Arterial road widening projects/ Magill and Portrush Roads intersection

Technical feedback – Magill Road/ Portrush Road intersection widening

The Bicycle Institute of South Australia (BISA) has reviewed the concept plans for this project. Members of the Norwood Payneham St Peters Bicycle Users Group (BUG) also attended the Community Information Session on Saturday 15 February, on our behalf. The feedback provided herein represents the views of both organisations.

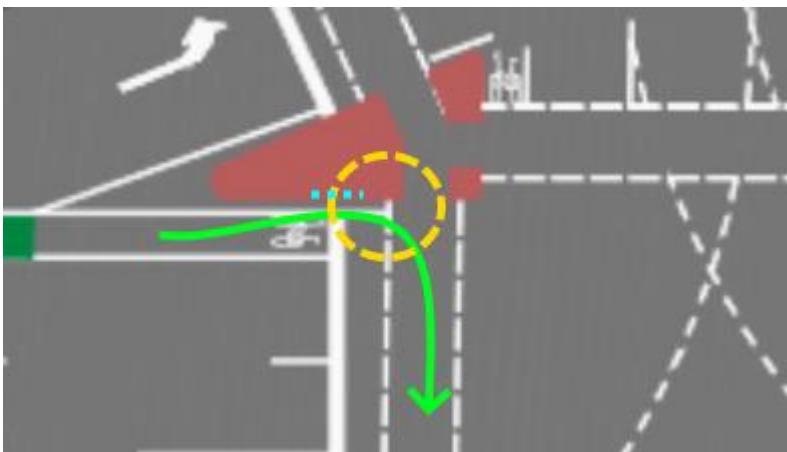
The cross section following illustrates the issues facing a cyclist in a too-narrow bicycle lane with poor tracking in the adjacent travel lane.

The cyclist has very little room to manoeuvre and no escape given an adjacent kerb. The truck’s wing mirror is at the edge of the bicycle lane and a hazard to the cyclist, who is working side-to-side out of saddle (as yet unaware of the truck coming up from behind). Even if not hit by the truck, any loose straps on the rear of the truck could swing out and hit the cyclist, potentially leading to swerving and/or crashing.

The red arrows illustrate the distance between the lane line and vehicular wheel path. Under central vehicular tracking, the wheels would be some distance from lane lines. This gives rise to an opportunity to enhance cyclist protection by using wider line marking for the bike lane, or by providing dark (i.e. not intended to be

visible) audio line marking on the outside of the bicycle lane. The latter in particular would provide feedback to drivers when they get too close to the bicycle lane.

This type of enhanced treatment is particularly indicated for grades of 5% or above. Here, the alternative of widening bicycle lanes to above 2.0m may encourage cars to enter the bicycle lane.

Diagram 1: Sheltered stand-up lane

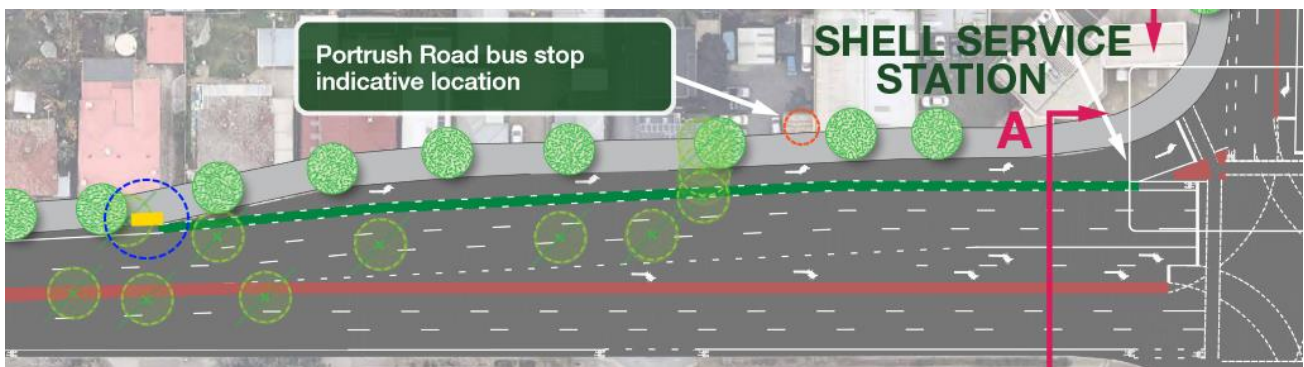
- b) On the western leg of Magill Road, where the left turn comprises a double left turn; and the southern leg of Portrush Road, where the stand-up lane is greater than about 60m in length, “sheltered” bike lanes should be provided – along with convenient access to signalised crossing opportunities. This is explained further in diagram 1, below.
- c) Where the bicycle lane transitions into a stand-up lane on the western leg of Magill Road, there should be a minimum “no conflict” length between the two. Diagram 2 explains this concept.

The long stand-up lane provides access for high-speed (“strong and fearless”) road cyclists who are comfortable riding in traffic. For others, providing a convenient kerb ramp in the area shown in yellow (and circled in blue) would enable a footpath-level bike path to be provided, separate to both the footpath and roadway. As this would be adjacent to the kerb, a small additional buffer should be provided between the kerb face and bike path. (This can be as simple as a white line delineating the space or be part of an attractive streetscape design.)

Diagram 2: Bicycle lane transitioning into a stand-up lane: minimum “no conflict” area

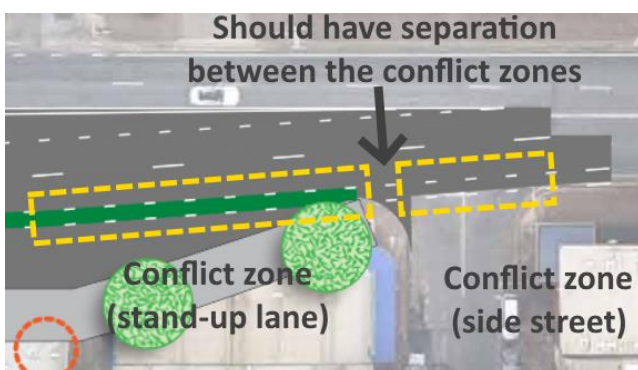
The likely conflicts in the two zones shown are different. A driver turning left out of Adelaide Street and then left at Portrush Road would be tempted to ‘nip around the corner’ at Adelaide Street. This increases the likelihood that they do not adequately pause and check for cyclists before turning, or yield to an approaching cyclist – drivers often assume they travel much faster than cyclists even when turning, giving rise to a poor sense of relative speeds and distance requirements to safely yield.

A safer design is to provide a section of solid line-marking with no conflict zone between the two types of conflict areas. This indicates cars need to yield when exiting Adelaide Street, and then when crossing the

stand-up lane. It also enables a cyclist to better focus on detecting conflicts. To be effective, the length of separation needs to be at least as long as a car park space, but longer depending on the speed environment (i.e. 6-10m). In this example, this could be achieved by constructing a kerb protuberance in the 'no stopping' area forward of parking in Adelaide Street.

The following diagram shows the north-western slip lane as per the concept, compared to the same with these features applied.

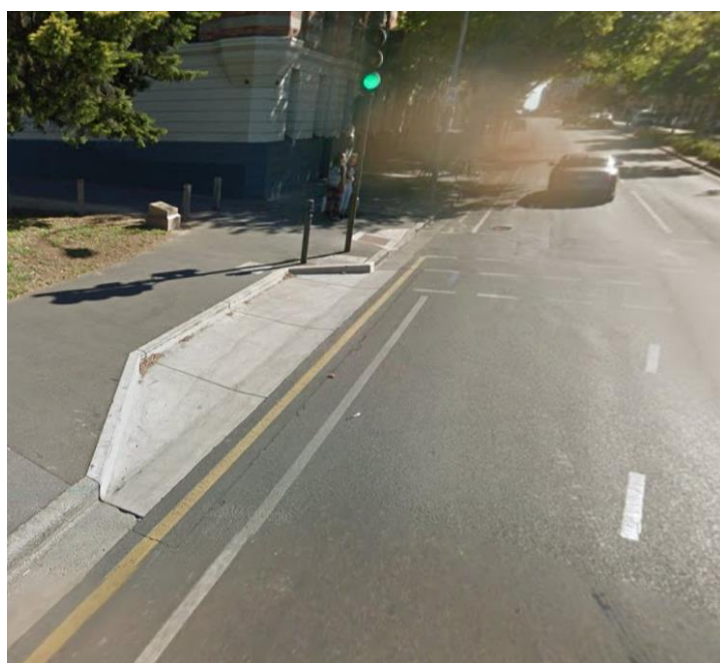
- a) Slip lanes are hazardous to pedestrians and must not be provided in high pedestrian areas. Where provided, slip lanes should employ a high angle (70°) design that encourages traffic using the slip lane to see and yield to pedestrians and opposing vehicles.

- b) Where a large-radius or large-width slip lane must be provided to enable heavy vehicle to negotiate the left turn, the area not required by cars and smaller trucks should be line-marked with chevrons to create the impression of a high angle slip lane. As this area will be used by left-turning cyclists, it should not include pavement bars or similar to more actively direct traffic.

- c) A cyclist turn bay should be provided near the pedestrian crosswalk of a signalised slip lane, forming a forward storage area outside the line of traffic for cyclists to wait in if a truck is turning, and also facilitating a hook turn.

- d) Where bicycle lanes are provided on the departure side of an intersection over a slip lane, this bicycle lane should be coloured green to highlight its presence and encourage traffic using the slip lane to yield to cyclists.

Yellow = chevroned area, green = bicycle lane, blue = cyclist turn bay.

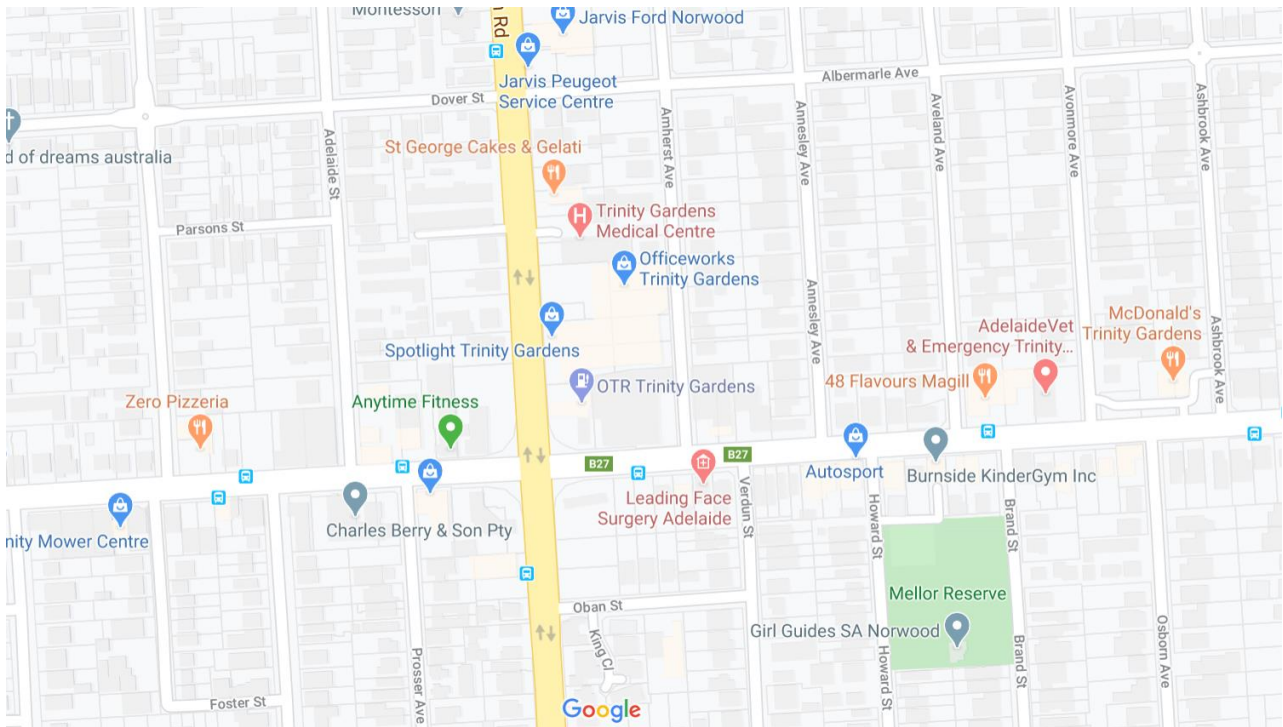
Signalised crossings can provide access across arterial roads and therefore form a useful part of a local cycling route. BikeDirect and Council routes should be reviewed for local route connections within the project footprint, while BISA and local bicycle user groups (BUGs) can provide information about actual travel patterns. Such routes may indicate supplementary travel patterns and therefore works that should be delivered as part of the project, such as an additional kerb ramp, extension of a shared use path, etc.

The Magill Road/Portrush Road concept does not address connection to local routes.
